## ANN ARBOR HISTORIC DISTRICT COMMISSION

### Staff Report

**ADDRESS:** 209 Buena Vista Avenue, Application Number HDC12-007

**APPLICATION:** The applicant seeks HDC approval to add a gabled dormer that is fifteen feet one-and-a-half inches wide, with two casement windows in the east elevation of the dormer and two skylights, and clad in Hardie shingles to the rear (east) side of the house. The applicant also seeks approval to extend the existing brick chimney two feet above the ridgeline to meet code.

# WEST ELEVATION

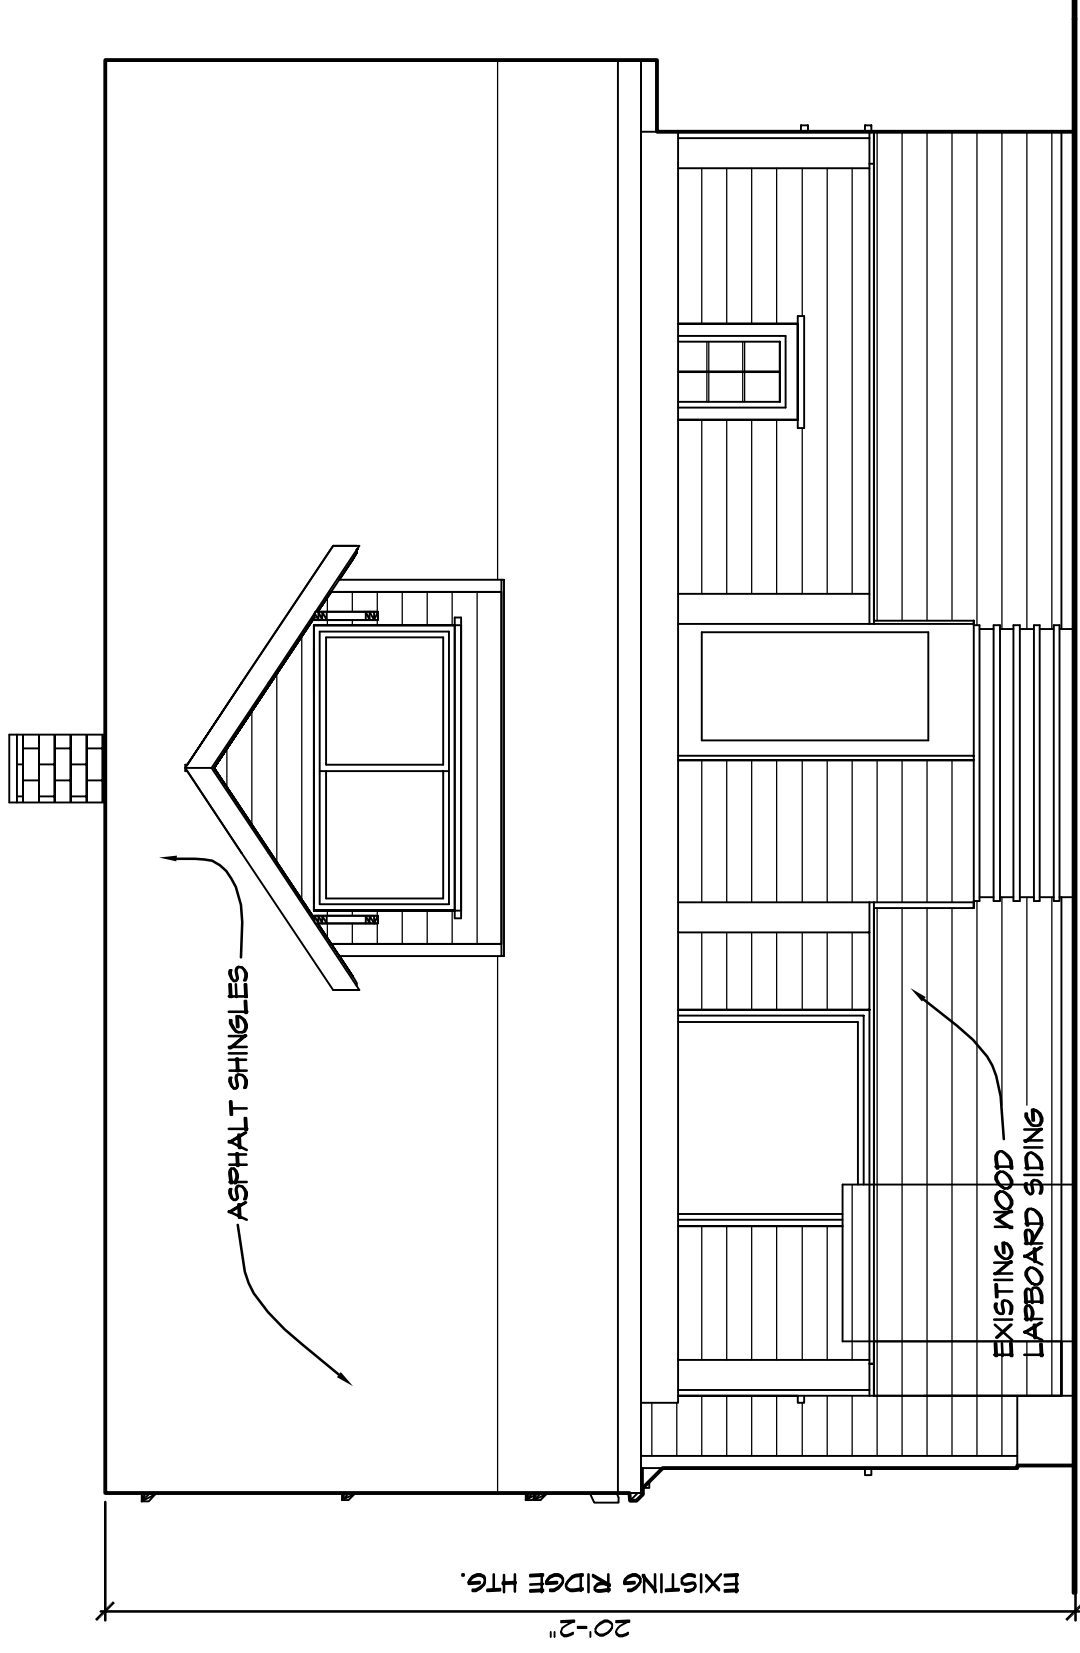
I've been reviewing your application for the dormer to be added to your house at 209 Buena Vista and noticed that the architect had indicated that they chimney is to be extended to meet code. A couple of questions for you:

- How high is the chimney to be extended?
- What material is the extension to be composed of? Brick as well?

The building code requires that chimney flues terminate 2 feet above the closest point of any roof within ten feet. I have not climbed up on the roof to verify the existing chimney height but believe it will need raising as it is enveloped by the proposed dormer addition - so to be safe we indicated such on the drawings. I anticipated using matching materials (brick).

# EAST ELEVATION

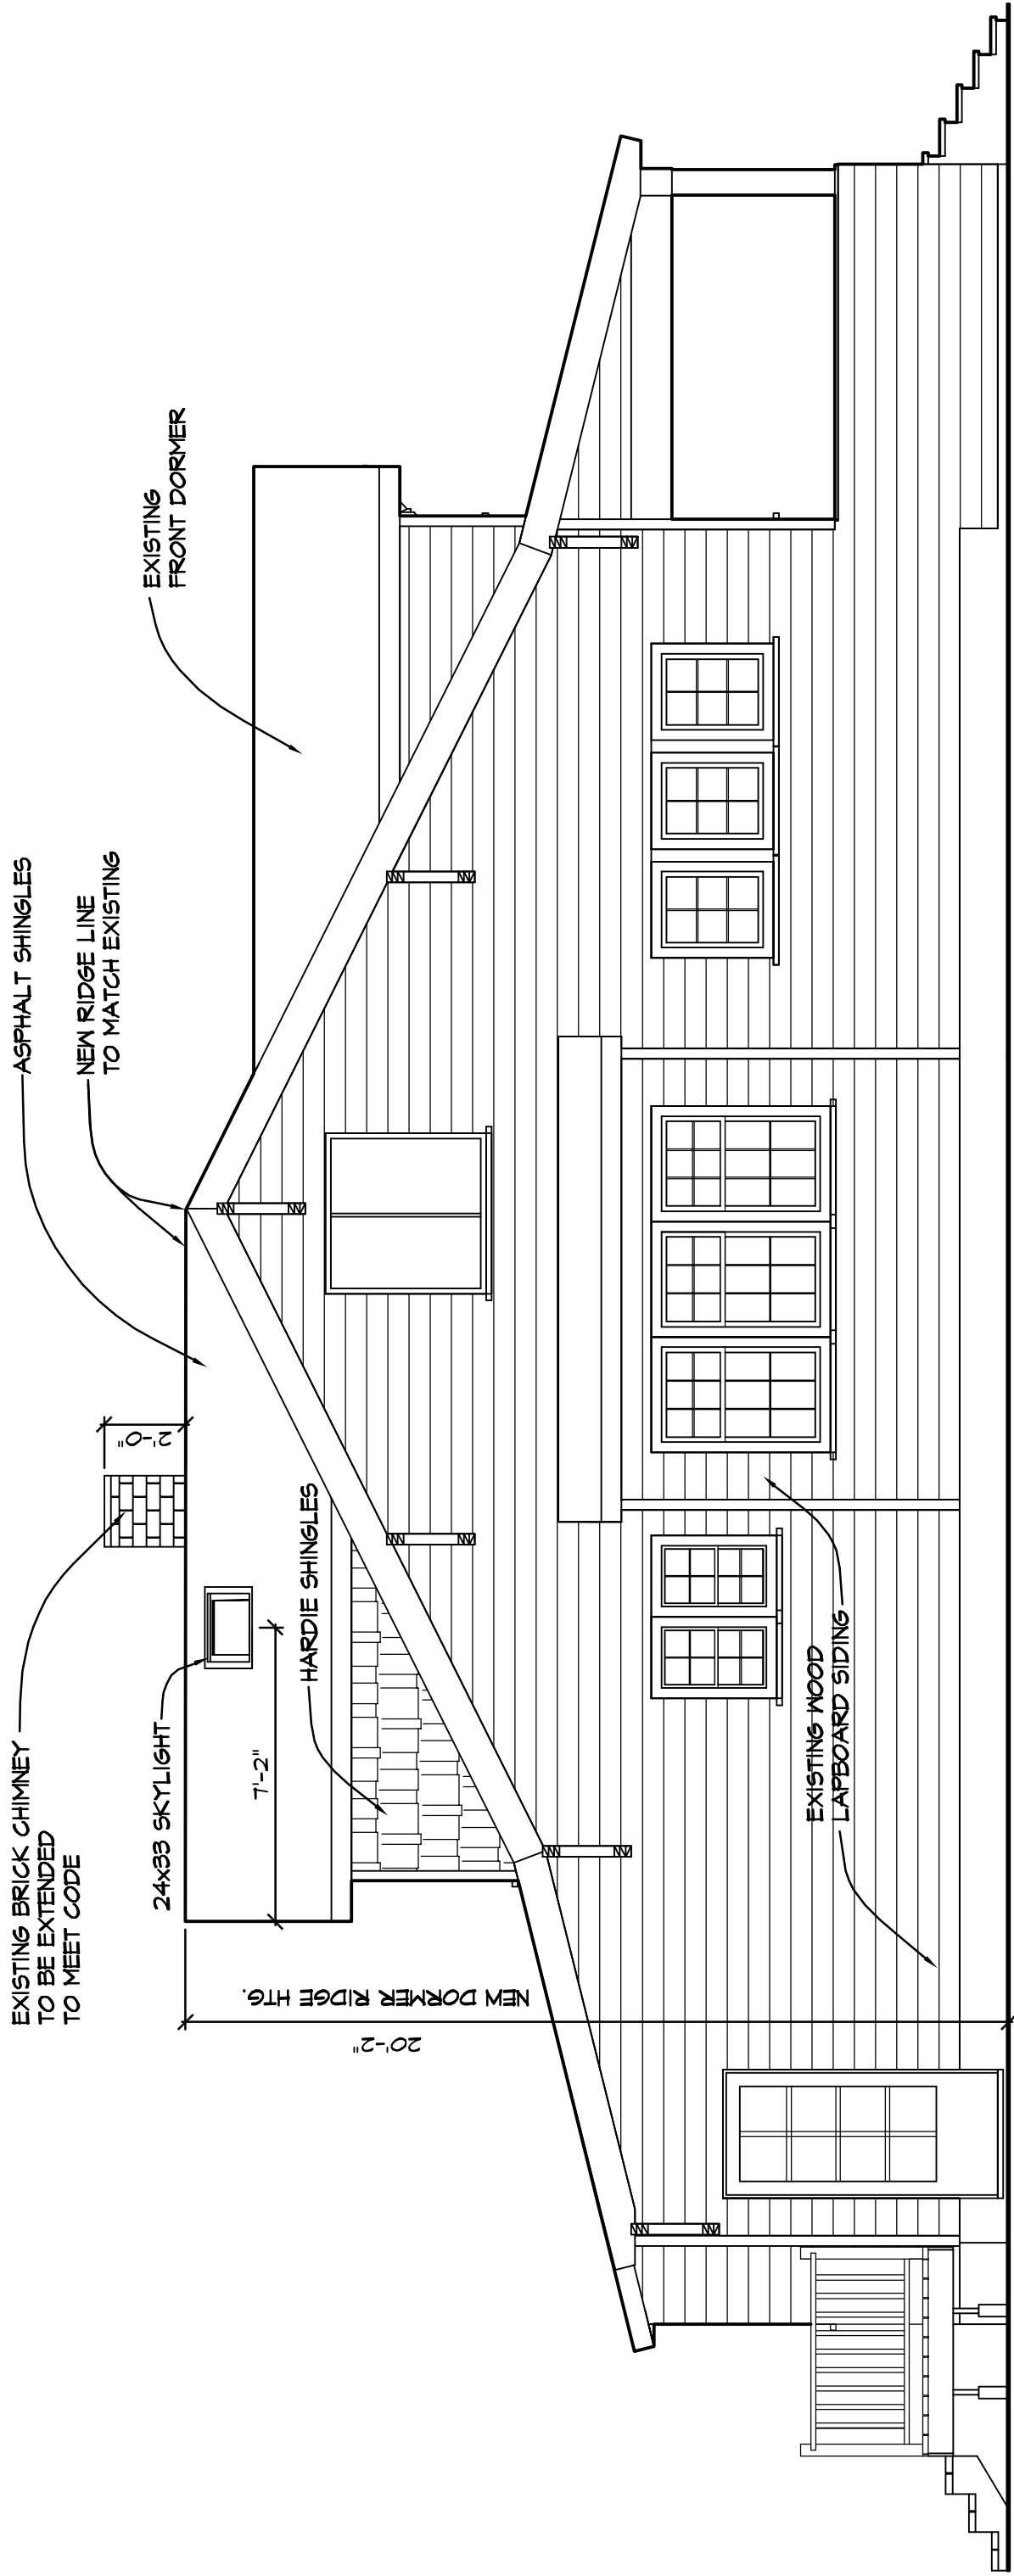
1. The 15' wide dormer is proposed on the rear, inconspicuous side of the house. The pitch of the roof is similar to the street-facing dormer on the house, it is located at the same ridge height as the current roof, and its proportions are consistent and compatible with the rest of the house. It appears that the new dormer will not be visible from Buena Vista Avenue. The proposed dormer and casement windows are compatible in design with the existing house and its location on the least-character-defining elevation of the house is appropriate. The skylights are located on the new, non-character-defining roof and are not visible from Buena Vista Avenue.

3. The new construction is differentiated from the original construction, which has wood clapboard siding, by the use of Hardie shingles, a cement-fiber material, and the installation of two skylights. The two casement windows are larger and do not duplicate the muntin configurations of the character-defining windows.
